DESCRIPTIVE REPORT

Type of Survey Hydrographic
Field No. RA-10-1-86
Registry No. H-10228

State Alaska
General Locality Seymour Canal
Sublocality North and West of Swan Island

HYDROGRAPHIC TITLE SHEET

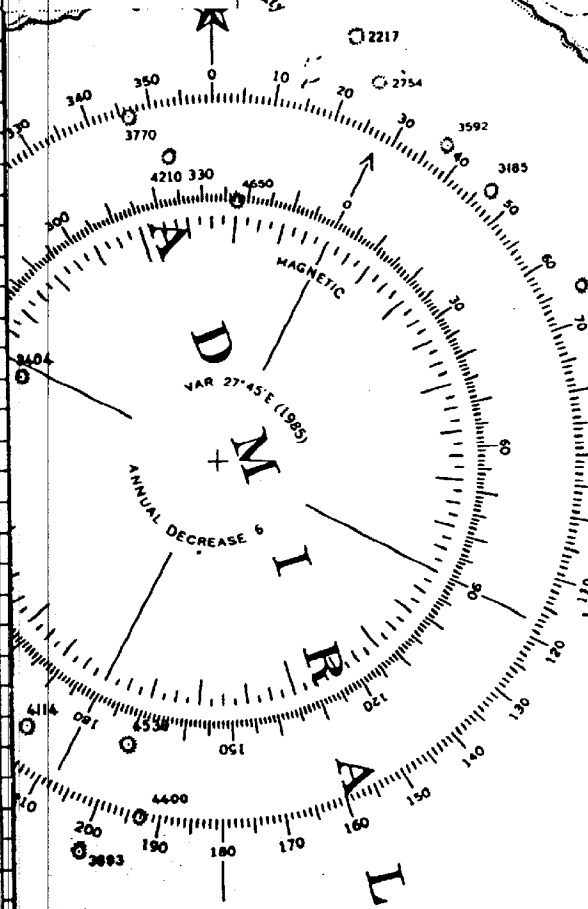
Survey Depth: 5 fm

Charted Depth: 7 fm 58°01'30"N

Method of Investigation: The channel connecting King Salmon Bay and Fools Inlet was developed at 50 meter spacing. Depths of 5 fm to 7 fm were found in the middle of the channel.

Recommendation: Change the charted 7 fm to a 5 depth.

ITEM A: Change 2 1/4 fm to 1 fm
ITEM D: Add 1 fm
H-10228
SEYMOUR CANAL ALASKA

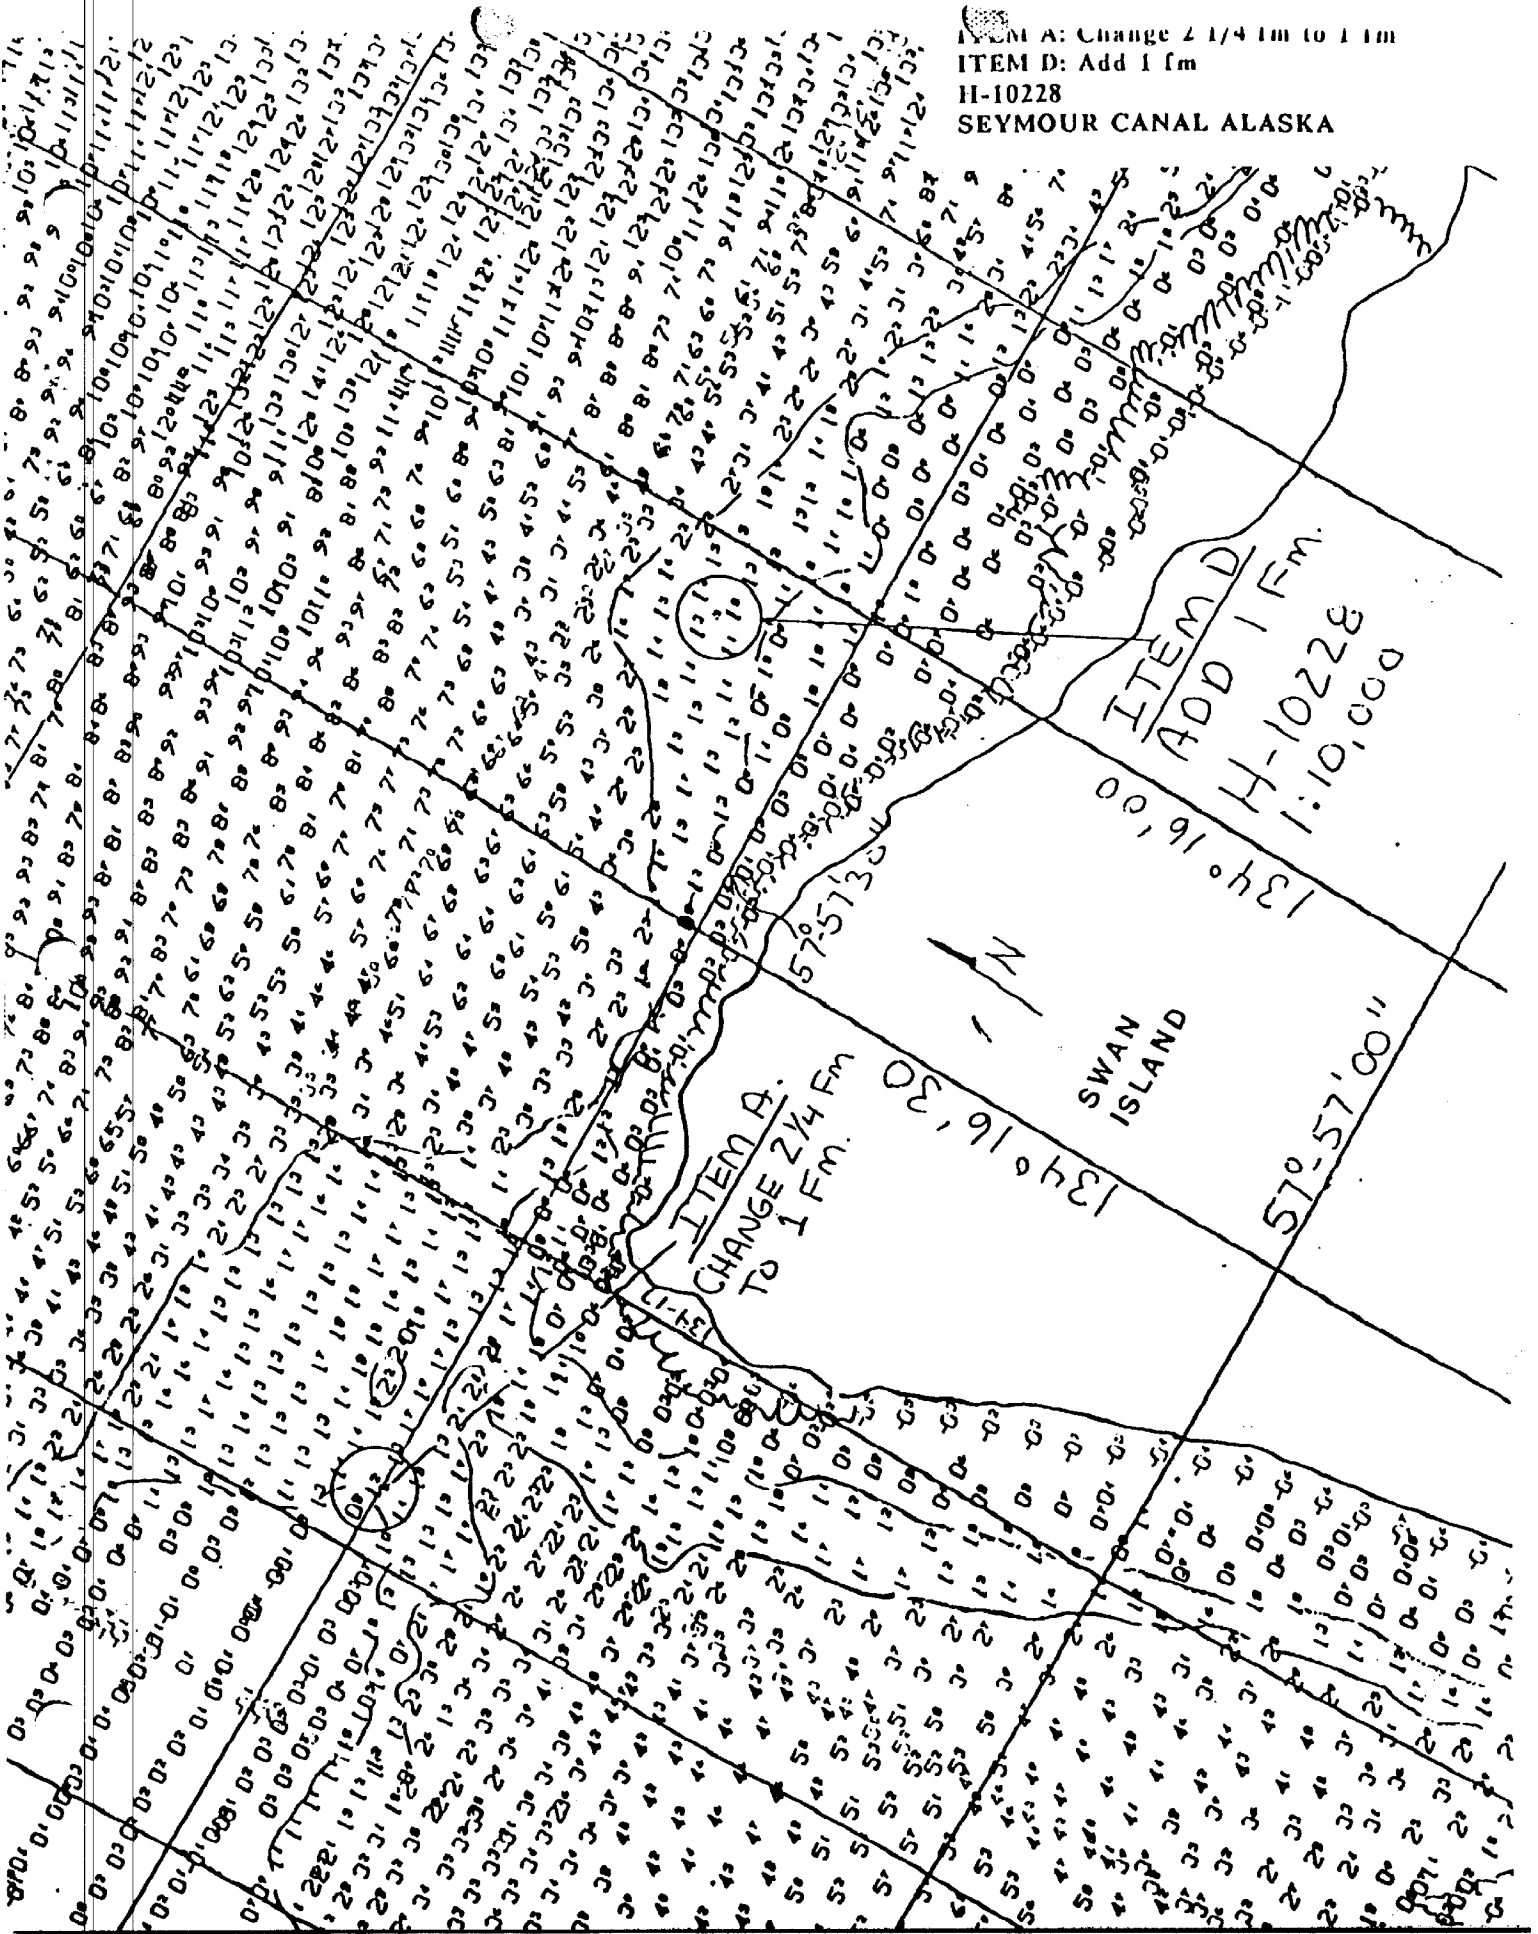
ITEM A:
CHANGE 2 1/4 Fm
TO 1 Fm.

ITEM D:
ADD 1 Fm.
H-10228
1:10,000

Recommendation: At the present chart scale, the charted 2 1/4 fm depth is a misleading representation. Change the charted depth to 1 fm.

Recommendation: Add a 1 fm depth at the above position.

ITEM B: Change 1 1/2 fm to 1/2 fm

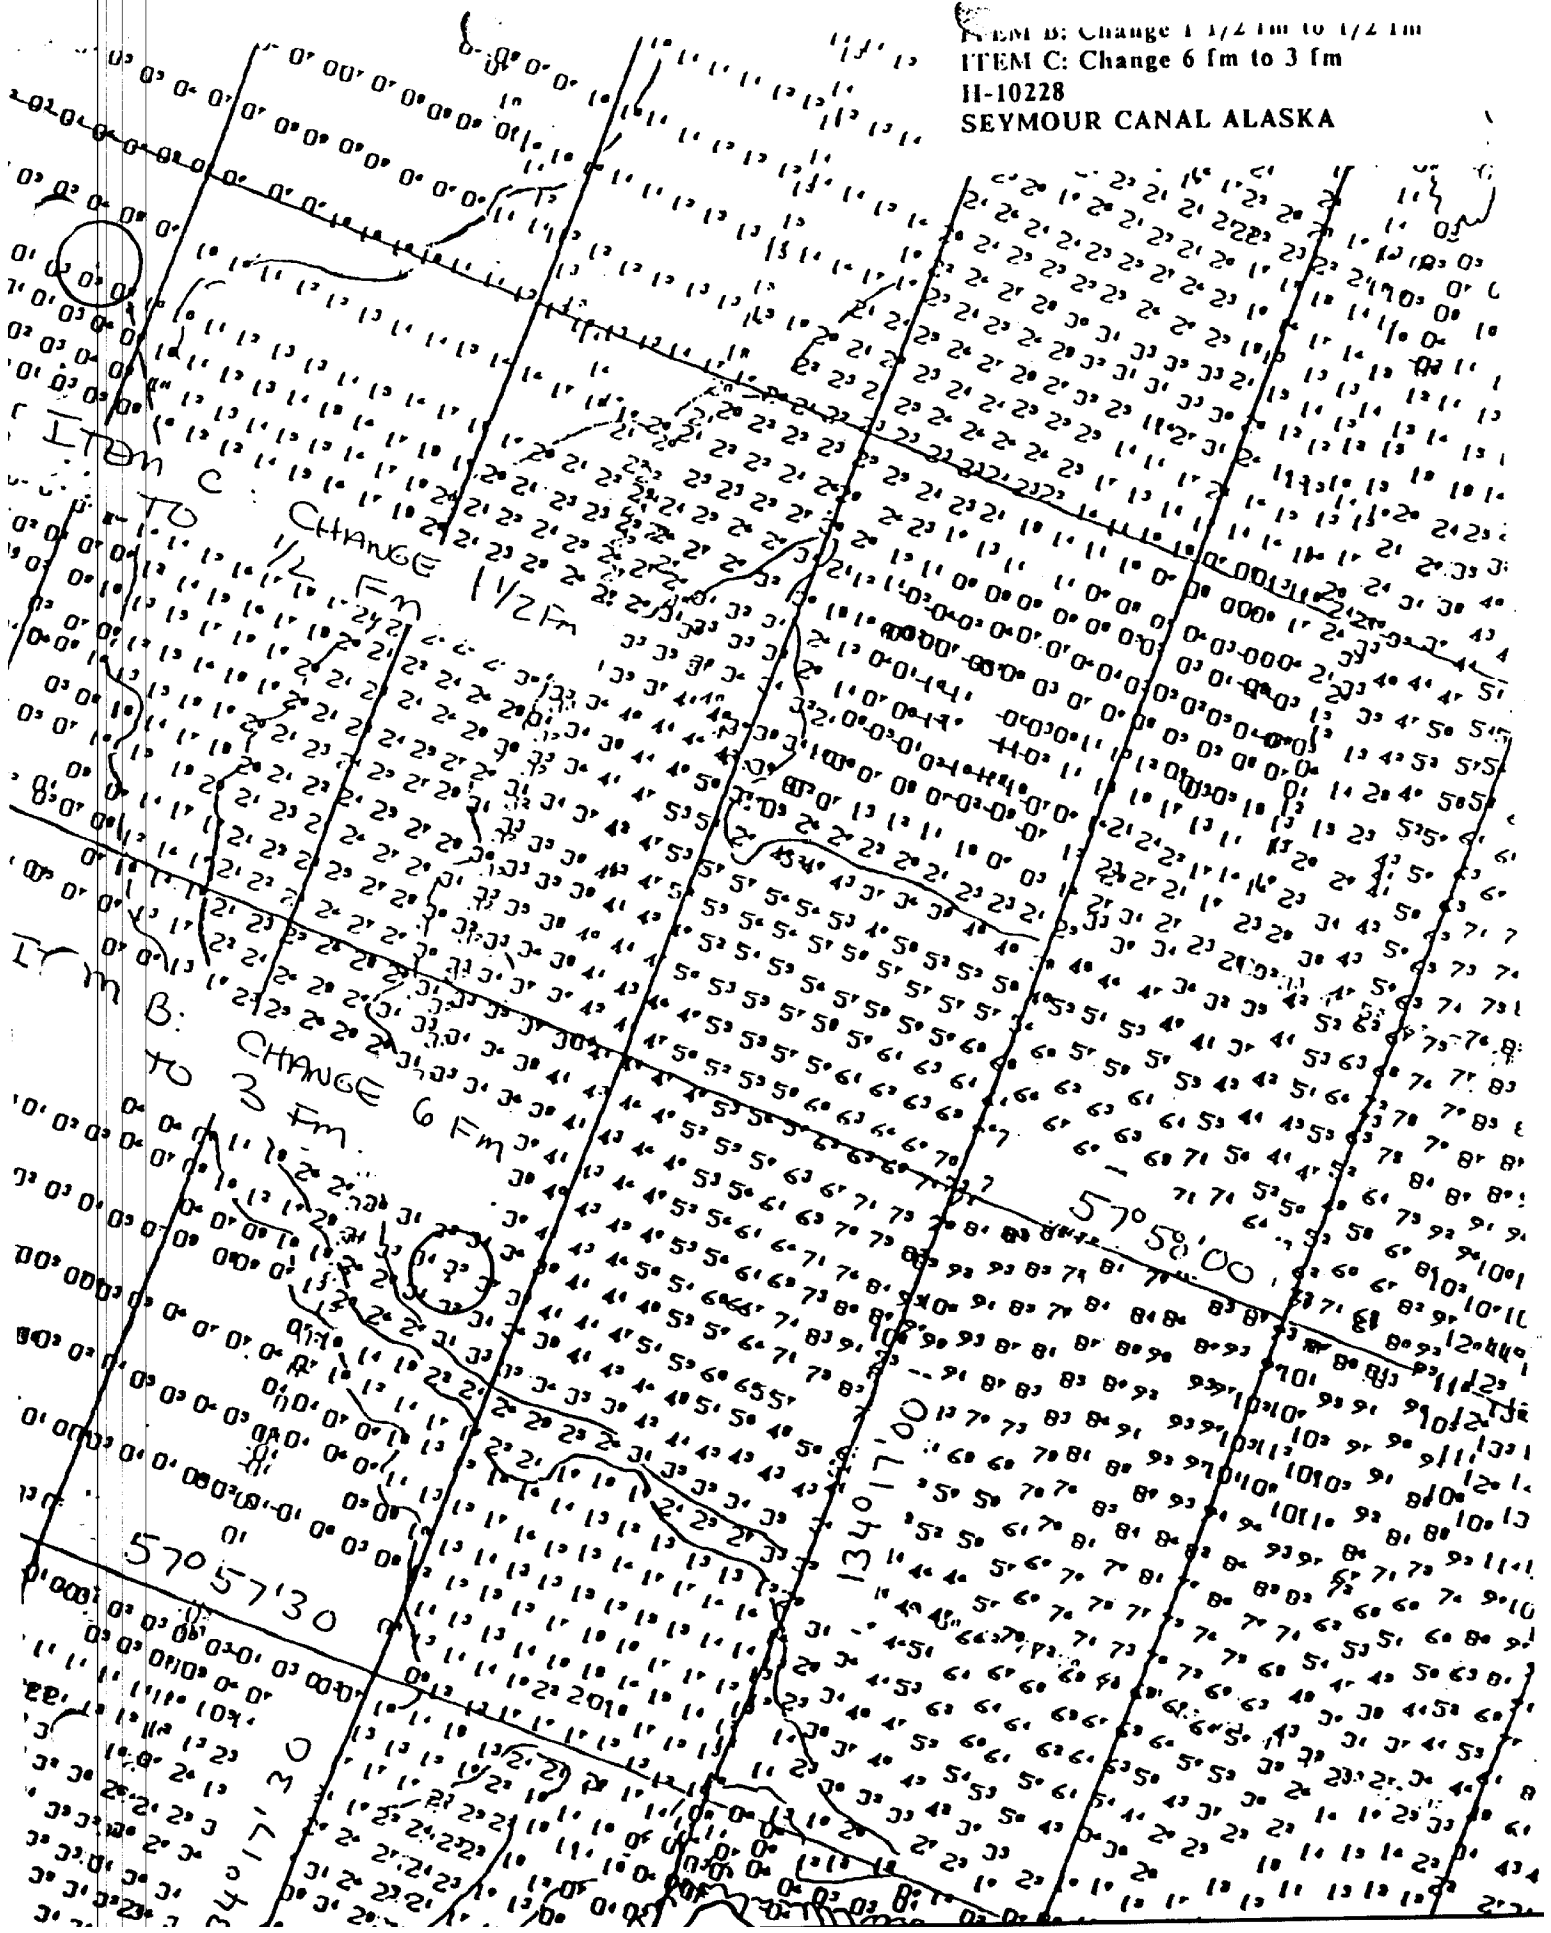
ITEM C:
TO CHANGE
1/2 Fm
1/2 Fm

ITEM B:
TO CHANGE
3 Fm
6 Fm

Recommendation: Change the charted 6 fm depth to 3 fm.

Recommendation: Change the charted 1 1/2 fm depth to 1/2 fm.
